SUBJECT: Lake Wauwanoka Dam Phase I Inspection Report

LAKE WAUWANOKA DAM  
JEFFERSON COUNTY, MISSOURI  
MISSOURI INVENTORY NO. 30080

PHASE I INSPECTION REPORT  
NATIONAL DAM SAFETY PROGRAM

PHASE I REPORT  
NATIONAL DAM SAFETY PROGRAM

NO. 1: UPSTREAM FACE OF DAM

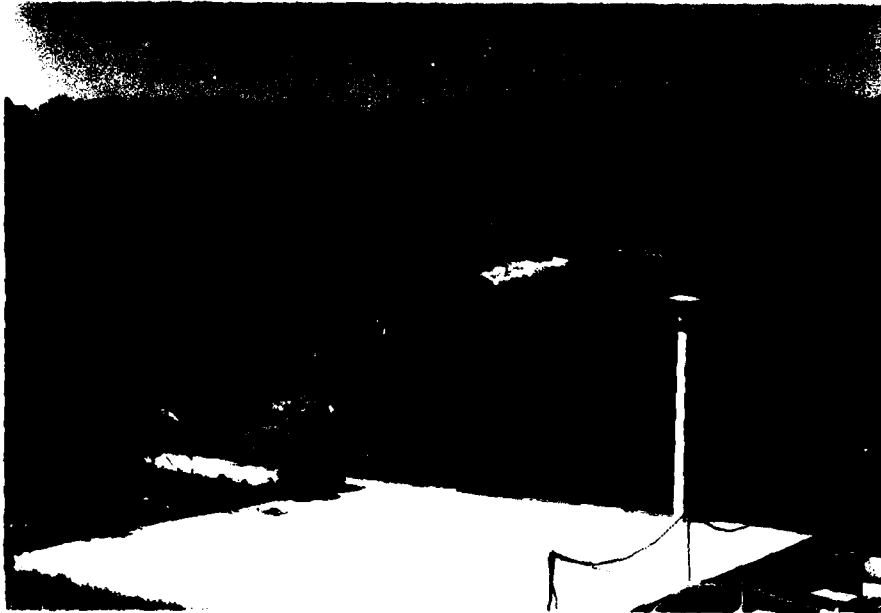
b. Dam. The visible portions of the upstream and downstream slopes (see Photos 1 and 2) of the dam appeared to be in satisfactory condition, although numerous small trees and dense vegetation were present on the downstream face as well as the area adjacent to the dam. Riprap, consisting of crushed limestone rock about 2- to 3-inches in size, serves to protect the upstream face of the dam above and below the normal waterline across a section of the dam near the center. The remainder of the upstream face above the waterline is grass covered. No slides, sloughing, or cracking of the embankment was noticed. No holes or animal burrows were noticed in the dam slope or elsewhere. However, due to the dense vegetation covering the downstream face, it could not be concluded that none exist.

(1) Provide slope protection across the remaining portions of the upstream face of the dam above and below the normal waterline in order to prevent erosion by wave action or fluctuation in lake level. If stone riprap is to be used, it is recommended that the smaller (2- to 3-inch size) stone be covered with a layer of larger size stone in order to insure stability of the smaller size course.
